Second Addendum to Environmental Impact Report

Addendum Date: August 10, 2018

Project Title: Geary Corridor Bus Rapid Transit Project

Project Sponsor: San Francisco Municipal Transportation Agency (SFMTA)

Figure 1 Geary/Masonic Bus Shelter

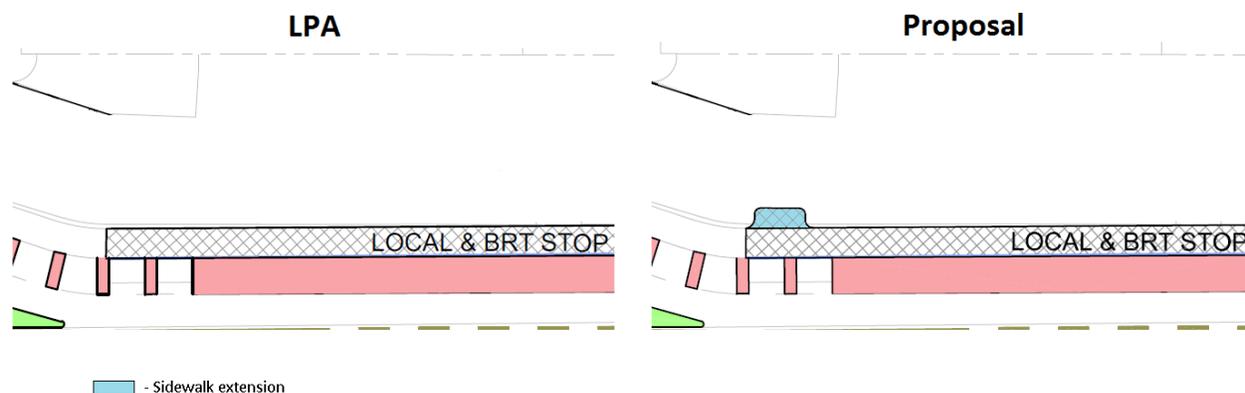
The Hybrid Alternative/LPA design at the outbound Masonic Avenue bus stop provided only the existing sidewalk footprint for bus stop amenities, such as a bus shelter. The revised design extends the existing sidewalk at the Geary/Masonic outbound bus stop to the north into an adjacent public parking lot to create additional space to relocate the bus shelter. The sidewalk expansion would be approximately 7 feet wide (into the parking lot) and 17 feet long (parallel to the roadway). The bus shelter would be relocated north from the location proposed in the FEIR to a location within the expanded sidewalk. This expansion provides more space for pedestrians to walk and to wait for the bus. This change is shown in **Figure 2**.

Figure 2 Representative Examples of Bus Stop Shortening (left) and BRT/ Local Stop Consolidation (right)

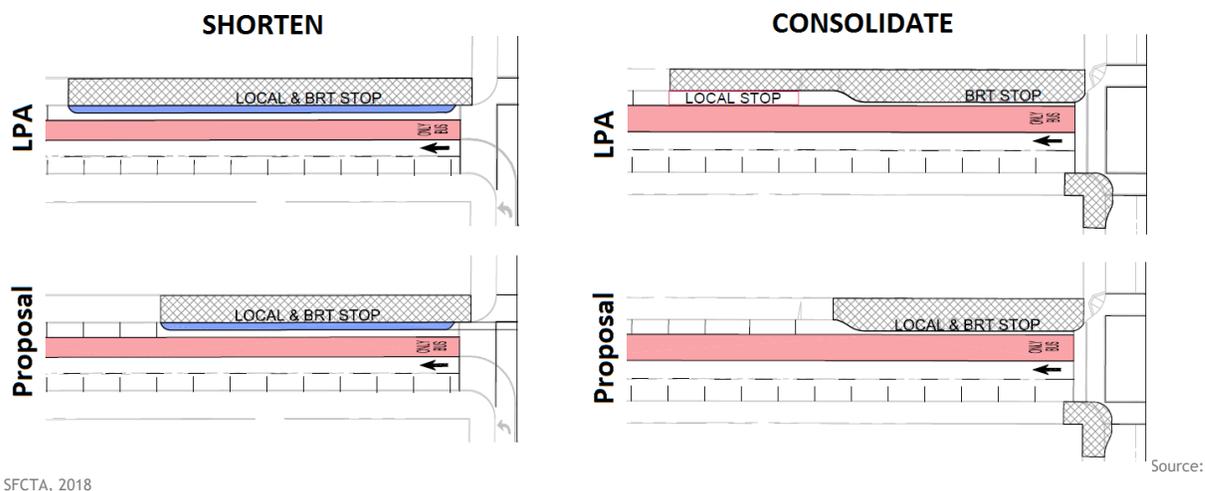
The Hybrid Alternative/LPA included bus stops long enough for three 60-foot articulated buses at most of the stops served by both BRT and local service. At some of these stops, the Hybrid Alternative/LPA also anticipated separate places for the local and BRT services to stop within one bus stop area. **Figure 1** shows these typical configurations in the top row (labeled 'LPA'). The individual bus stop designs analyzed in the FEIR can be found in Appendix A of the FEIR. SFMTA proposes to shorten each stop served by BRT and local buses to accommodate two buses instead of three buses. At stops where separate places were previously proposed for BRT and local buses to stop, SFMTA proposes to consolidate the local and BRT bus services at a single point at each stop. **Figure 1** depicts both of these types of changes. These changes are proposed to improve transit performance and passenger experience as further described in the analysis below.

In areas where the length of the bus stop is shortened, a shorter bus bulb would be constructed. Since the precise length of each bus stop as proposed in the FEIR under the Hybrid Alternative/LPA varies, the reduction necessary to achieve a length of approximately 120 feet (sufficient to accommodate two buses) also varies by stop but is generally between 20 and 60 feet. In some cases, bus stop shortening preserves additional parking and loading as described under **Analysis of Potential Environmental Effects** below. The type of bus stop described in the FEIR would remain unchanged (i.e. Shelter Plus or Signature).

Figure 3 Geary: Polk to Van Ness Traffic Striping

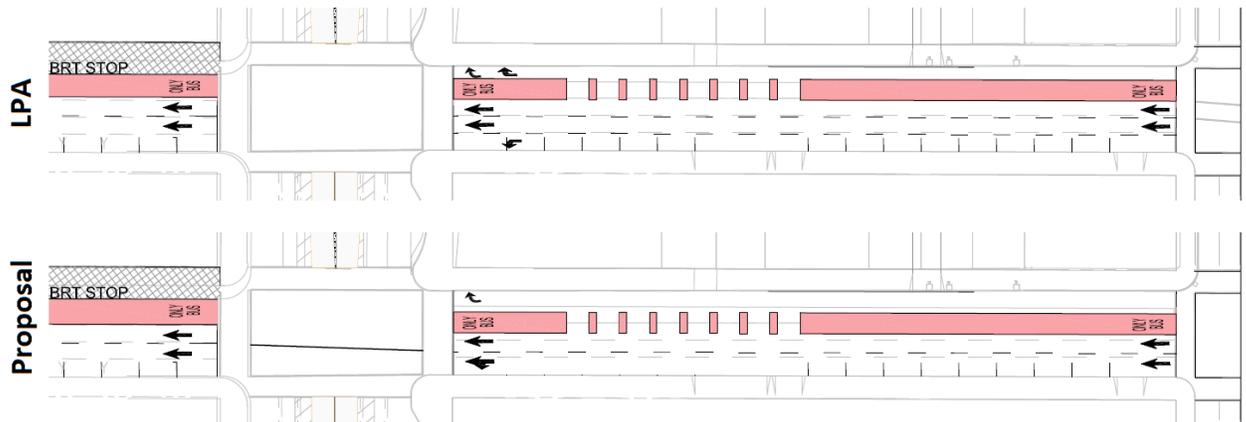
As described in the FEIR, the Hybrid Alternative/LPA included the following configuration on Geary Street for the westbound approach to Van Ness Avenue: one peak-hour tow-away left turn lane, two mixed-flow through lanes, one bus-only lane, and one right turn lane, for a total of five lanes (Figure 3). Five traffic lanes would require narrow traffic lanes or narrowing of the existing sidewalk.

SFMTA proposes to maintain the existing roadway and sidewalk widths and restripe the outbound lanes to provide the following configuration: one peak-hour tow-away shared left turn/through lane, one general mixed-flow through lane, one bus-only lane, and one right-turn lane, for a total of four lanes. This configuration would match the lane configurations on the blocks immediately east and west of this block.

This change would result in the loss of six parking spaces to provide more capacity for westbound left-turn movements outside of the peak-hour two-away time periods. The change to the street configuration for Geary Street between Polk Street and Van Ness Avenue is shown in **Figure 3**.

Figure 4 Laguna Stops

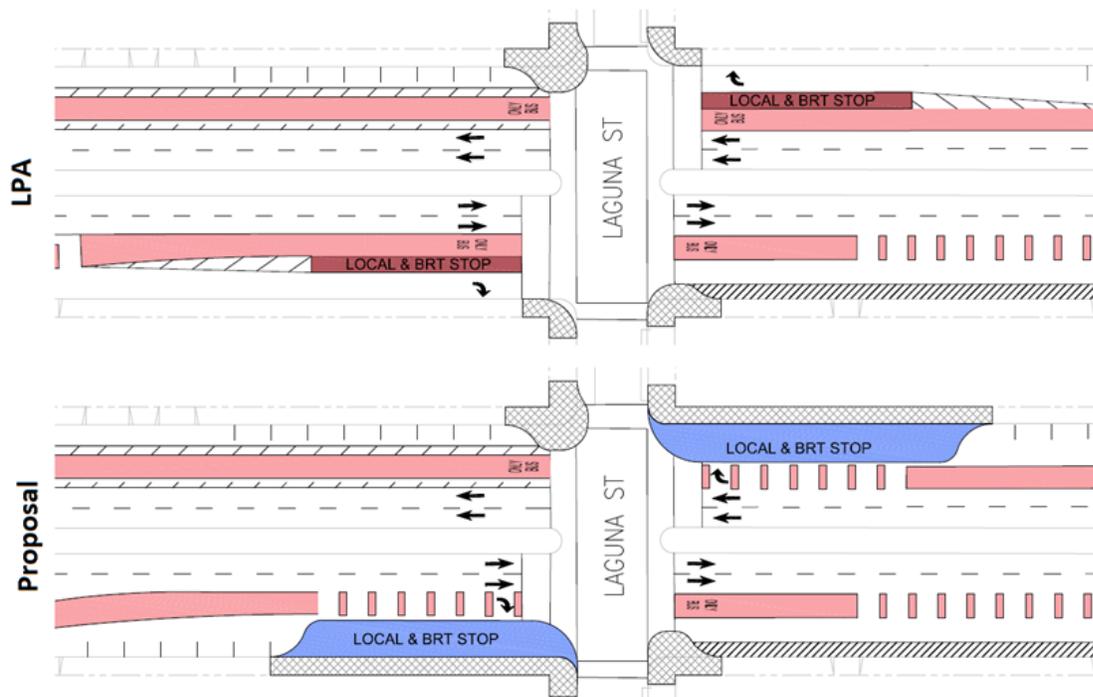
As described in the FEIR, the Hybrid Alternative/LPA would reduce the number of inbound and outbound through lanes for mixed-flow traffic from four to two at Geary and Laguna, while adding a bus lane in each direction. In addition, the Geary BRT project design included construction and operation of transit islands for BRT service at inbound and outbound bus stops at Geary/Laguna. The islands would have separated buses from right-turning traffic; right-turning vehicles would have used a right-turn only lane between the transit boarding islands and the adjacent sidewalk. Due to the limited roadway width, trucks would not have enough room to turn right from Geary onto Laguna from the right-turn lane, necessitating a truck restriction on Laguna Street, similar to the restriction on trucks on Laguna south of Geary.

SFMTA now proposes to construct bus bulbs in place of transit islands along both the inbound and outbound approaches. The bus bulbs would be approximately 20 feet wide by 130 feet long, and create additional sidewalk space compared to the Hybrid Alternative/LPA.

Construction of bus bulbs in place of transit islands would result in a shared right-turn and bus-only lane at each bulb. This change would afford larger trucks the opportunity to make legal right-turns onto Laguna Street. In addition, this change responds to stakeholder input expressing a preference for bulbs instead of islands. The changes at the Geary/Laguna stops are shown in **Figure 4**.

Constructing bus bulbs and not transit islands would require the removal of five existing parking spaces where the sidewalk would be extended. However, the bus bulbs would preserve seven parking spaces previously assumed to be removed along Geary at the northeast and southwest approaches necessary to accommodate boarding islands, as shown in **Figure 4**.

Figure 5 Geary/Webster Modified Traffic Patterns

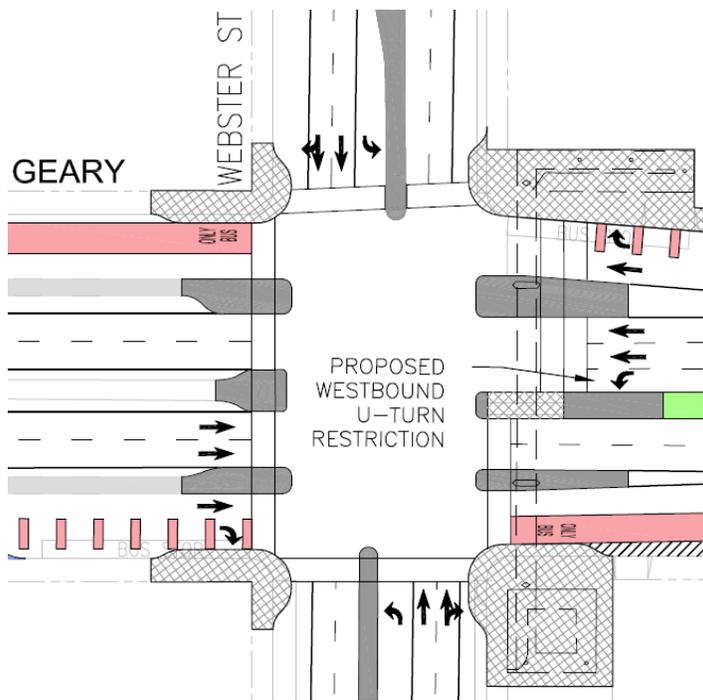
The Hybrid Alternative/LPA allowed drivers to make U-turns from the westbound approach on Geary Boulevard at Webster Street. U-turns at this intersection are permitted under existing conditions, and are made from the same lane as left turns.

SFMTA proposes to restrict U-turns at this location, requiring additional signage on-site to regulate traffic. This change would allow pedestrians to cross the southern half of the crosswalk while westbound traffic has a green signal for left hand turns. The Geary/Webster U-turn restriction is shown in **Figure 5**.

Figure 6 Hybrid Alternative/LPA Turning Movements

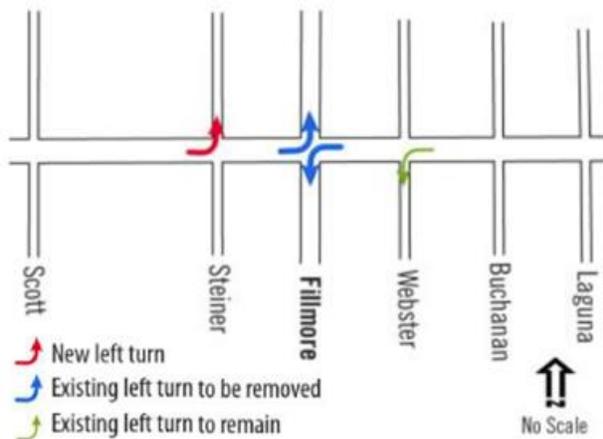
As described in the FEIR, the Hybrid Alternative/LPA would have altered existing traffic patterns by restricting eastbound and westbound left turns at the Geary/Fillmore intersection. The Hybrid Alternative/LPA also included installation of a new eastbound left turn lane and reconfiguration of the median at the Geary/Steiner intersection. The allowed turning movements in the Hybrid Alternative/LPA are shown in **Figure 6**.

SFMTA proposes to maintain the existing eastbound and westbound left turns at the Geary/Fillmore intersection, and continue restricting left turns in the eastbound direction at the Geary/Steiner intersection.

Figure 7 Geary/Steiner Intersection

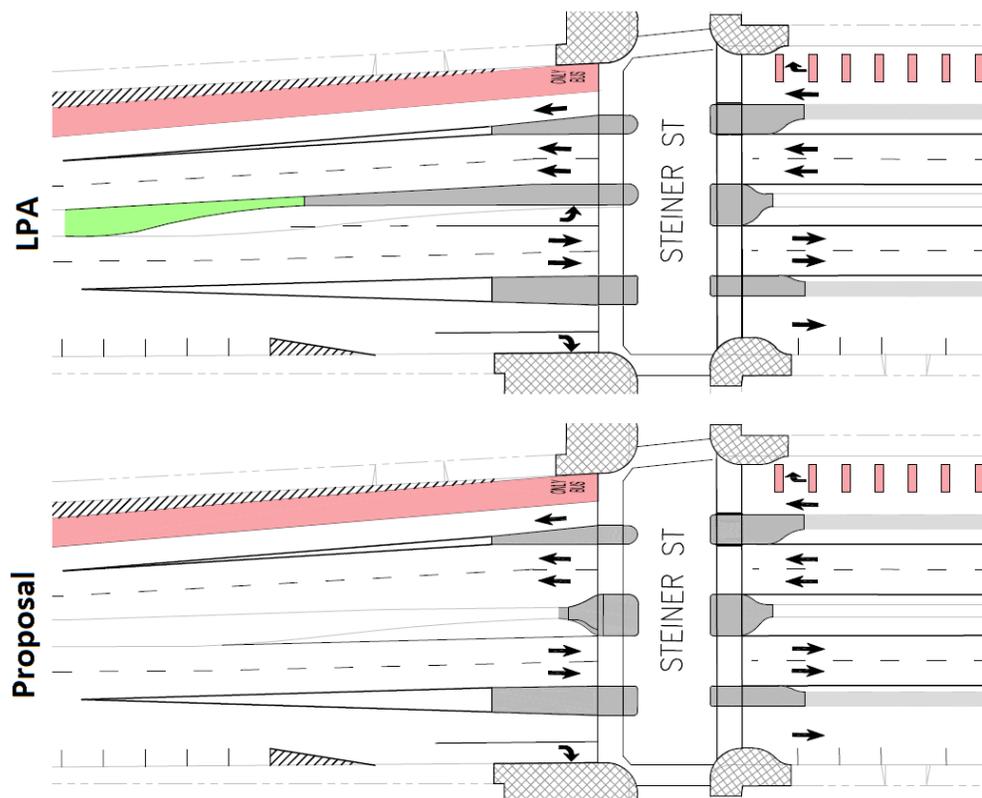
To restrict eastbound left turns at Geary/Steiner, the center median pedestrian refuge island in the west side crosswalk would be expanded. The median refuge island would be widened by about 10 feet compared to the Hybrid Alternative/LPA, as shown in **Figure 7**.
